FlowTracker Handheld ADV[®] Firmware Version 3.7 and Software Version 2.30 Release Notes

FlowTracker firmware version 3.7 and software version 2.30 have been released. All production systems shipped on or after March 31, 2009 have firmware version 3.7 installed.

Figure 1: Top Setting Wading Rod with SonTek Offset Brackets

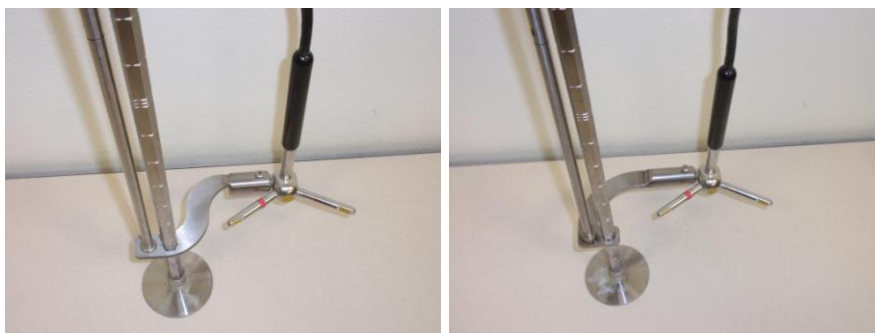
FlowTracker velocity data can now be adjusted for the possible effects of flow disturbance caused by the wading rod or other mounting device used to deploy the system in the field. When used, this correction results in a small increase in measured FlowTracker velocity and discharge values.

Laboratory tow tank tests have indicated that the FlowTracker probe and its mount can create a flow disturbance that may have a small impact (approximately 1.0%) on measured velocity data. The mount is most commonly a top-setting wading rod using an S or J offset bracket ([Figure 1](#)).

Firmware version 3.7 and software version 2.30 now include an option to apply a correction to velocity data, if desired. To apply a flow disturbance correction within the FlowTracker, set the **Mounting Correction** using option **8** from the **Setup Parameters** menu. You must specify the same mounting correction in software from the **Program Settings** dialog (Figure 2) to ensure the correction is applied to processed data. The software checks all data files to see what mounting correction has been applied. If the mounting correction used during data collection differs from the mounting correction specified in software, the software mounting correction will take precedence. This allows you to re-process older data files to apply the correction.
